Reliability Driven®
Service Bulletin No. 446

MODEL J4500	TYPE Field Change Program	SECTION/GROUP 3-Body	DATE June 14, 2017
SUBJECT A/C COMPRESSOR SUPPORT TUBE			
CONDITIONS

Figure 1. Reference view of front face of A/C compressor support tube.

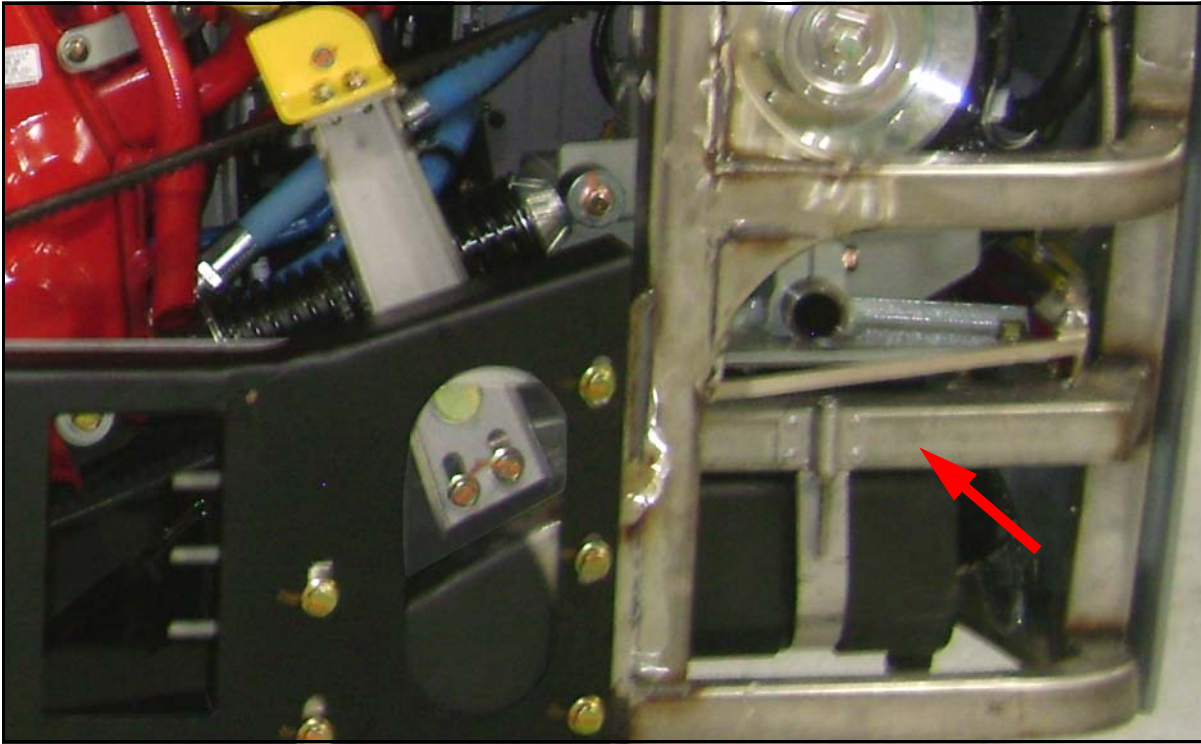
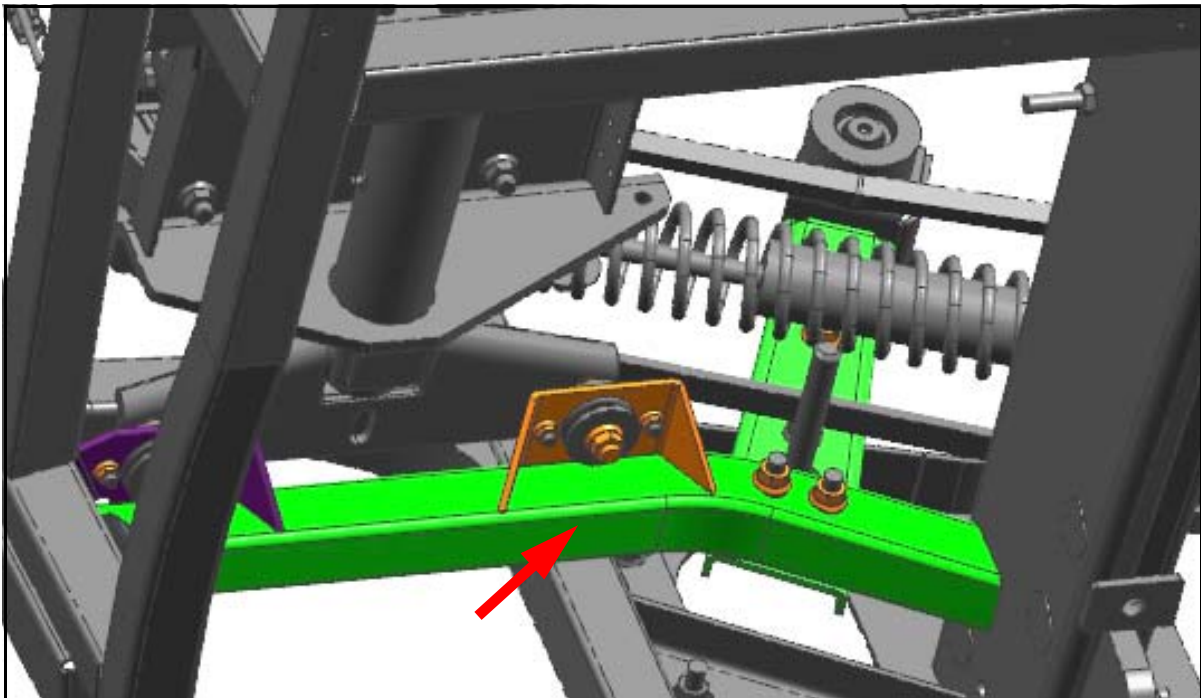
4. Visually inspect both faces of the A/C compressor support tube for stress damage (refer to Figures 1 and 2). Carefully inspect the area of the idler pulley mounting bracket.

If no cracks are found on the A/C compressor support tube upon visible inspection, proceed to Page 6 / Step 5, using retrofit kit 26-03-0111.

If a crack is found on the A/C compressor support tube upon visible inspection, proceed to Page 9 / Step 14, using retrofit kit 26-03-0111.

If the A/C compressor support tube assembly exhibits cracks that have completely propagated through the tube, proceed to Page 23 / Step 54, using retrofit kit 26-03-0110.

Figure 3. Idler pulley bracket angle drilled mounting hole dimensions.

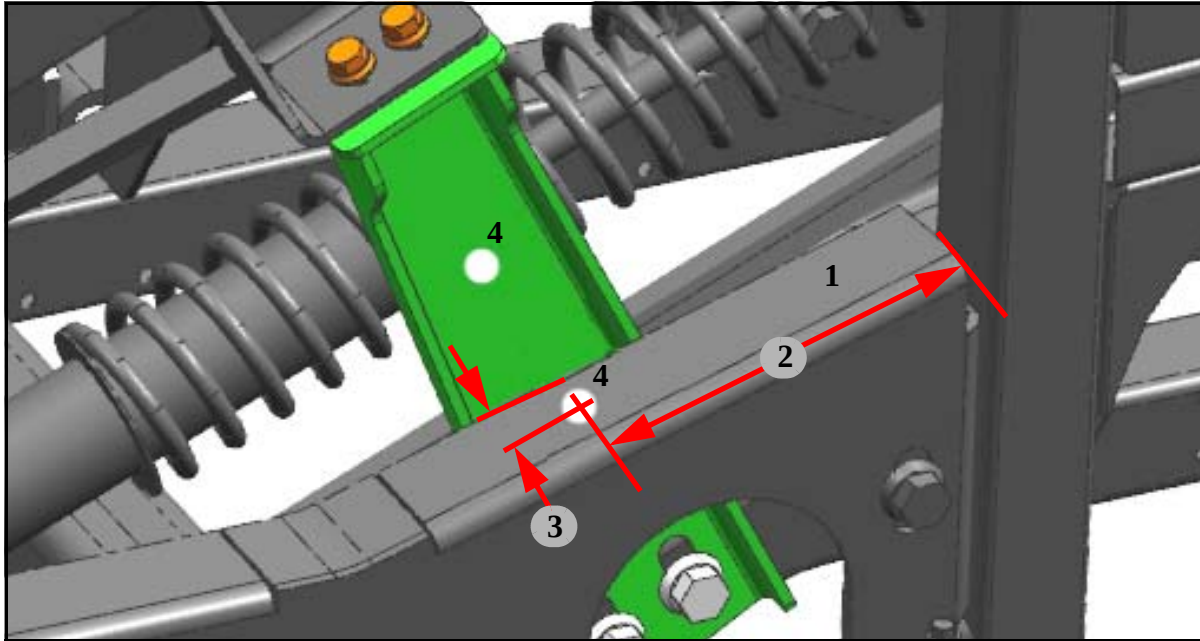
5. Locate the existing snubber bracket assembly shown in Figure 3. Remove and discard the existing snubber bracket and mounting hardware. Retain the idler pulley to be re-installed at a later step in this procedure.
6. Using a 17/32 inch drill bit and a drill, drill a mounting hole in the tie bar plate per the dimensions shown in Figure 3.

Item	Figure 3 Description
1	Tie bar plate
2	6.00 inch
3	0.87 inch
4	Mounting holes

Figure 4. Idler pulley bracket angle and snubber bracket installation.

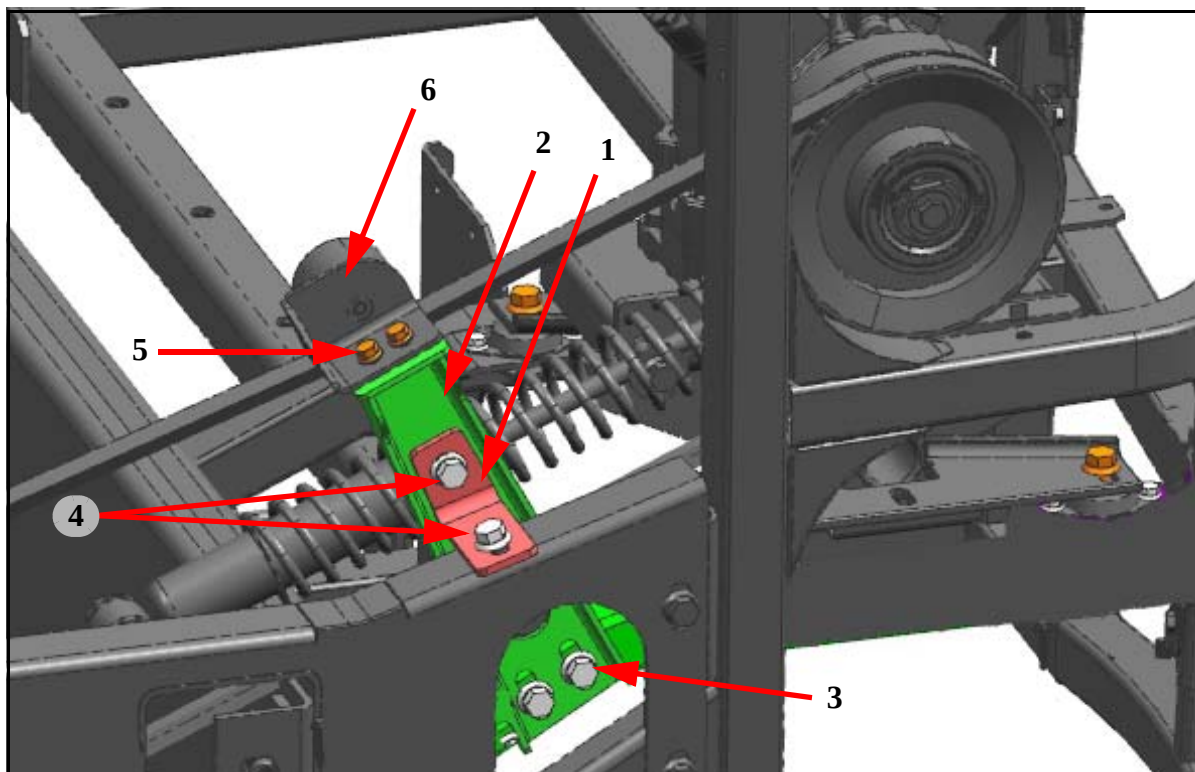
7. Orient and install the new snubber bracket, p/n 08-27-1327, idler pulley bracket angle, p/n 08-27-1326, and existing idler pulley as shown in Figure 4.

Item	Figure 4 Description
1	Angle, idler pulley bracket
2	Snubber bracket
3	Snubber bracket cap screw, p/n 19-01-1526 and flange nut, p/n 19-03-0497. Torque to 77-93 ft.-lbs
4	Angle cap screw, p/n 19-01-1577 and flange nut, p/n19-03-0497. Torque to 77-93 ft.-lbs
5	Idler pulley cap screw, p/n 19-01-1570 and lock nut,19-03-0535. Torque to 43-47 ft.-lbs
6	Idler pulley

Figure 5. Addition of shim(s) to achieve a 3/8 inch belt deflection.

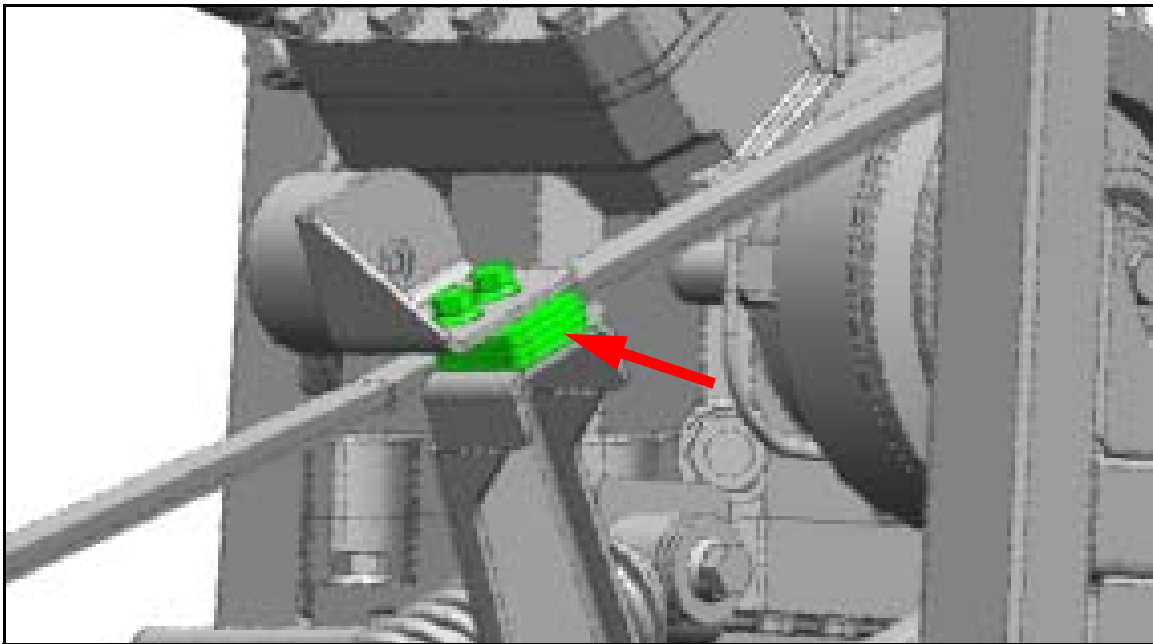
9. Remove the capscrew, p/n 19-01-1570 and lock nut, 19-03-0535 mounting the idler pulley to the snubber bracket. Orient and position the shims, p/n 08-27-1324, between the idler pulley bracket and the snubber bracket (refer to Figure 5).
10. Orient and install new capscrews, p/n 19-01-1736, through the idler pulley holes and the shim(s). Install the locknuts, p/n 19-03-0535, on the capscrews. Torque to 43-47 ft-lbs.

Only utilize a quantity of shims (one to three) that achieves a 3/8 inch belt deflection.

Figure 15. Weld information for support plates.

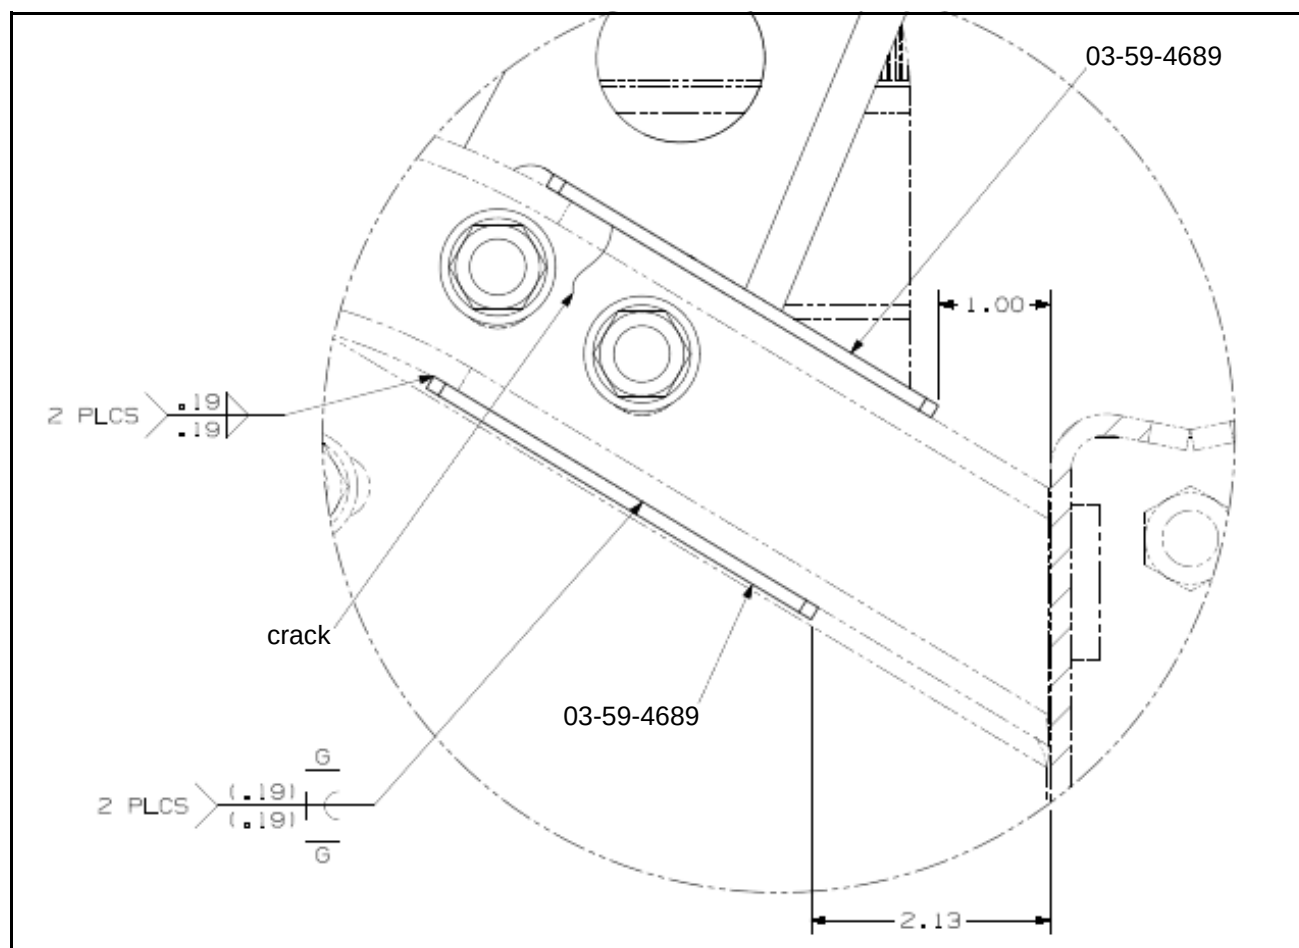
27. Perform the weld disconnect procedure.
28. Locate the existing snubber bracket assembly. Remove and discard the existing snubber bracket and mounting hardware. Retain the idler pulley to be re-installed at a later step in this procedure.
29. Drill a 0.125 diameter hole at both extreme ends of the crack. V-grind along the entire length of the crack. Fill drilled holes and v-grind with weld.
30. Orient and weld the support plates, p/n 03-59-4689, as shown in Figure 15.

Figure 16. Idler pulley bracket angle drilled mounting hole dimensions.

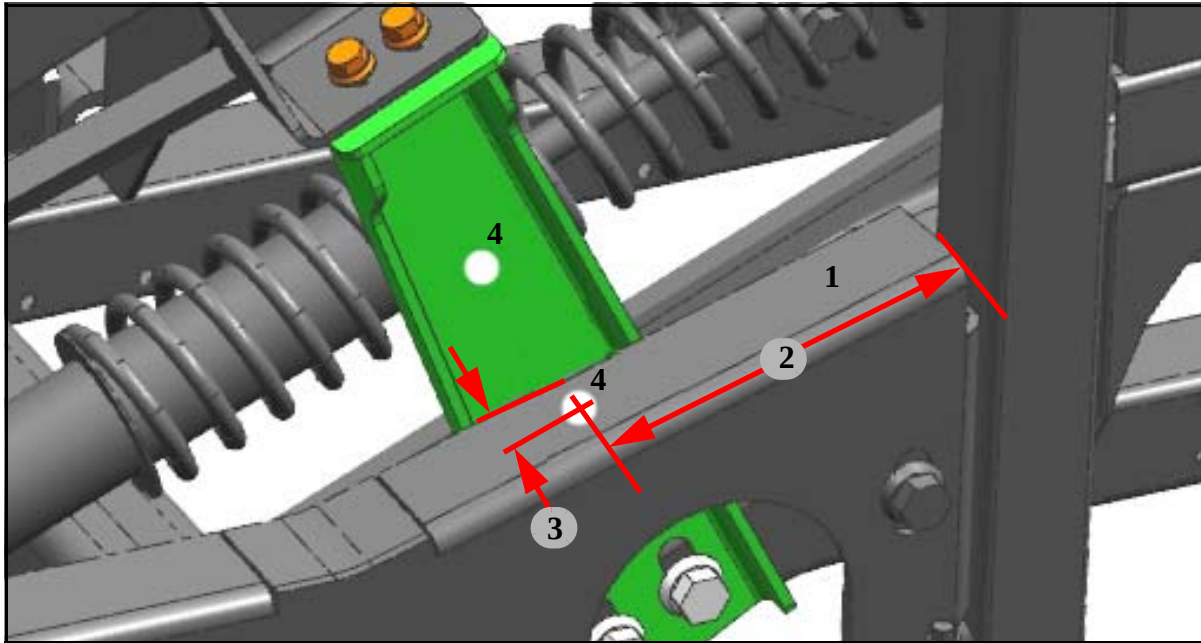
31. Using a 17/32 inch drill bit and a drill, drill a mounting hole in the tie bar plate per the dimensions shown in Figure 16.

Item	Figure 16 Description
1	Tie bar plate
2	6.00 inch
3	0.87 inch
4	Mounting holes

Figure 17. Idler pulley bracket angle and snubber bracket installation.

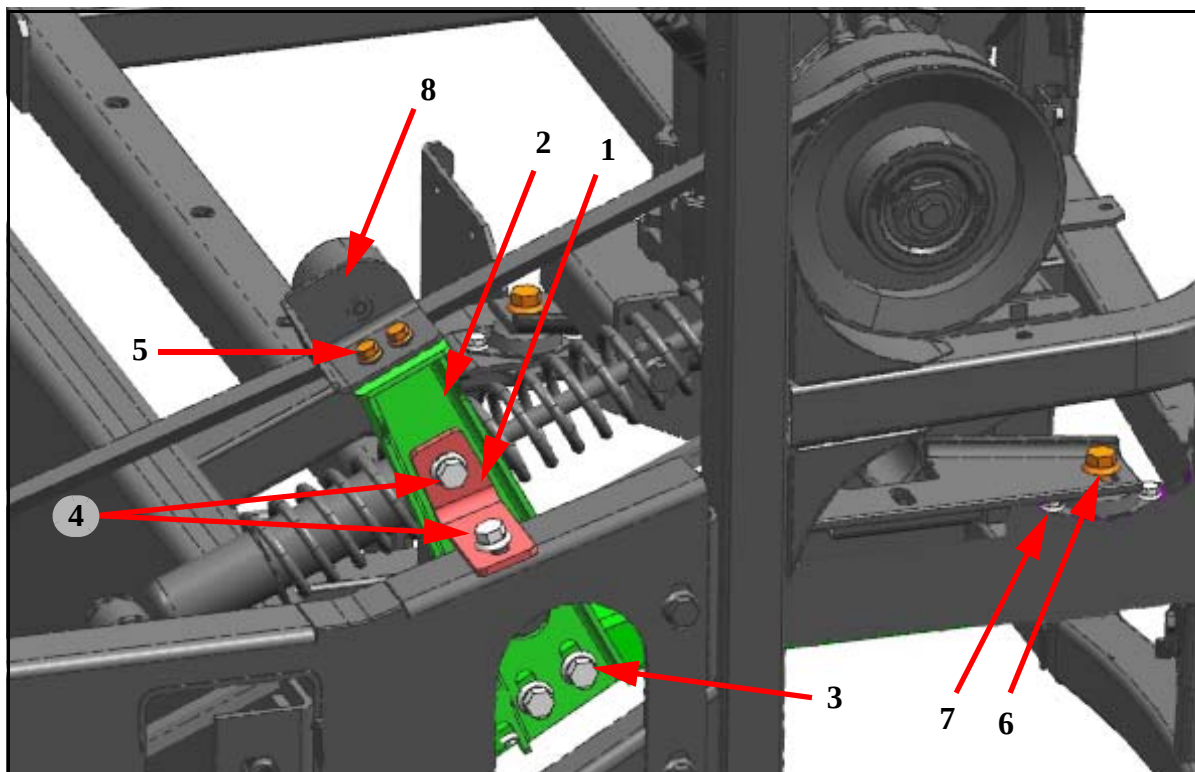
32. Orient and install the new snubber bracket, p/n 08-27-1327, idler pulley bracket angle, p/n 08-27-1326, and existing idler pulley as shown in Figure 17.

Item	Figure 17 Description
1	Angle, idler pulley bracket
2	Snubber bracket
3	Snubber bracket capscrew, p/n 19-01-1526 and flange nut, p/n 19-03-0497. Torque to 77-93 ft.-lbs
4	Angle capscrew, p/n 19-01-1577 and flange nut, p/n19-03-0497. Torque to 77-93 ft.-lbs
5	Idler pulley capscrew, p/n 19-01-1570 and lock nut,19-03-0535. Torque to 43-47 ft.-lbs
6	Compressor stabilizer (pivot plate / Figure 14), ref p/n's 19-01-1529, 19-03-0497. Torque to 63-77 ft.-lbs
7	Stabilizer to brackets (pivot plate / Figure 14), ref p/n's 19-01-1532, 19-03-0498. Torque to 14-16 ft.-lbs
8	Idler pulley

Figure 18. Addition of shim(s) to achieve a 3/8 inch belt deflection.

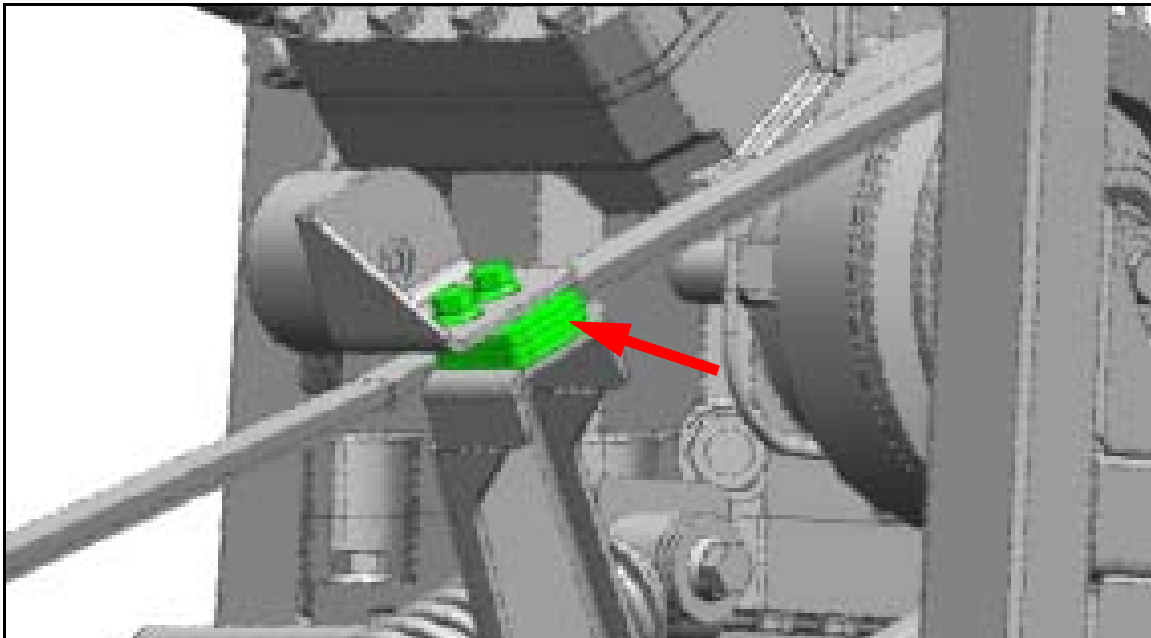
34. Remove the capscrew, p/n 19-01-1570 and lock nut, 19-03-0535 mounting the idler pulley to the snubber bracket. Orient and position the required quantity of shims, p/n 08-27-1324, between the idler pulley bracket and the snubber bracket (refer to Figure 18).
35. Orient and install new capscrews, p/n 19-01-1736, through the idler pulley holes and the shim(s). Install the locknuts, p/n 19-03-0535, on the capscrews. Torque to 43-47 ft-lbs.

Only utilize a quantity of shims (one to three) that achieves a 3/8 inch belt deflection.

Figure 31. Weld information for new tube assembly.

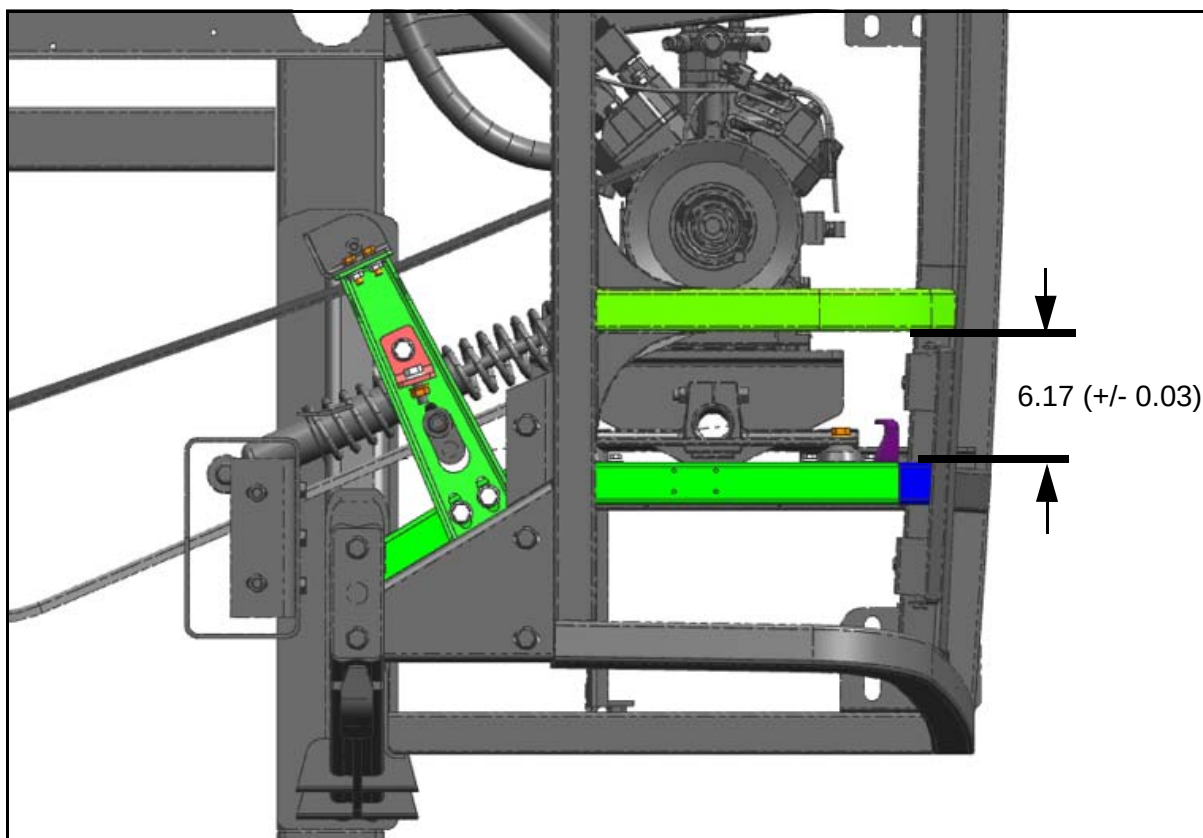
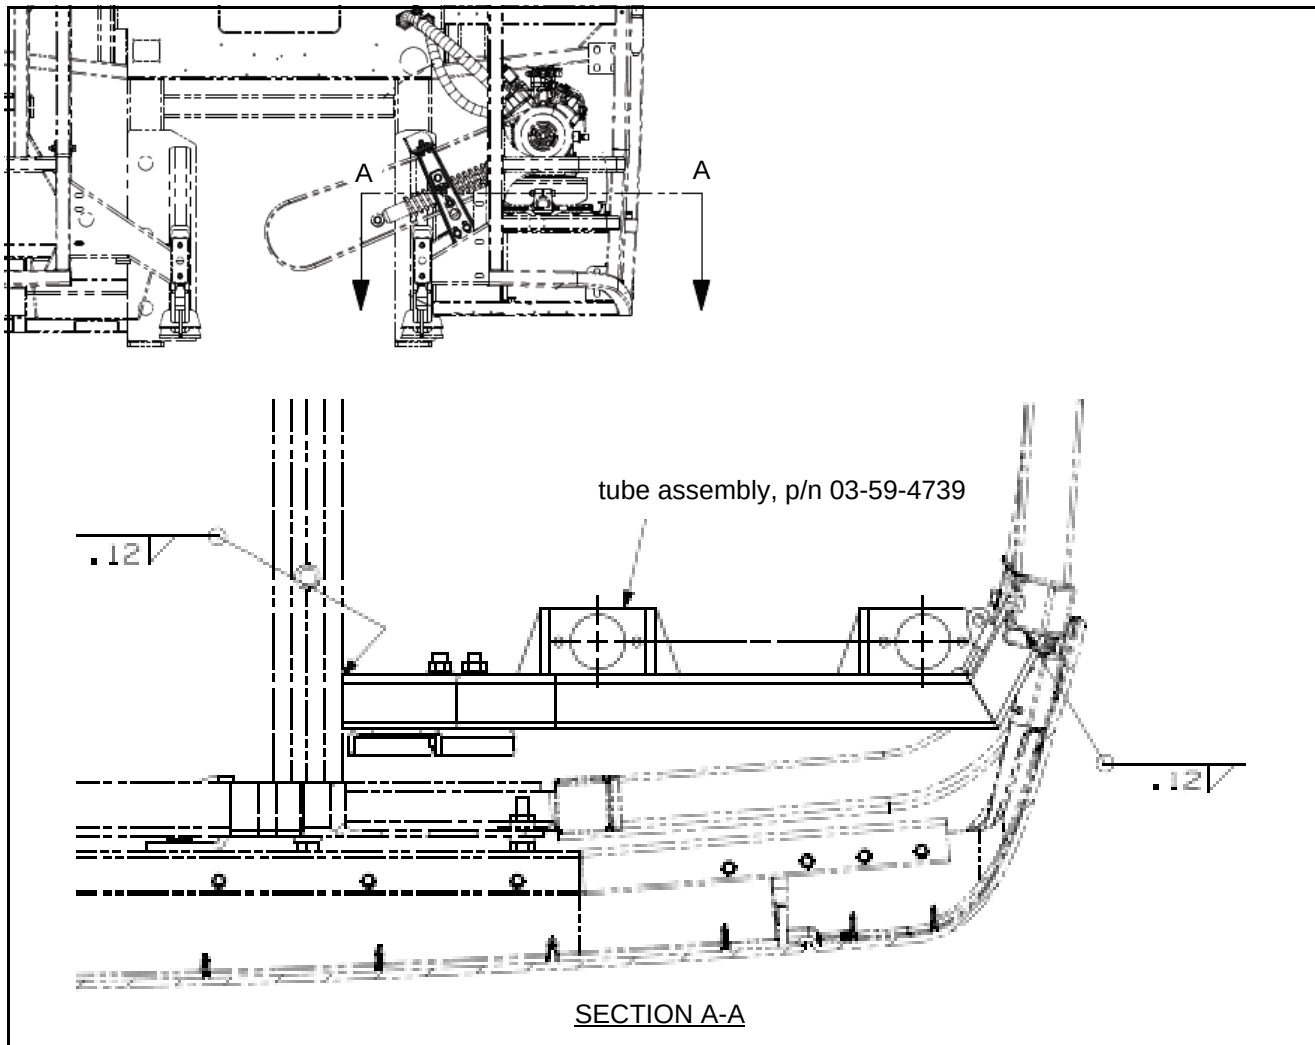
67. Perform the weld disconnect procedure.
68. Carefully cut and grind away existing cracked support tube shown in Figures 30 and 31.
69. Orient and weld the new tube assembly, p/n 03-59-4739, to the existing structure and engine rail as shown in Figures 30 and 31.
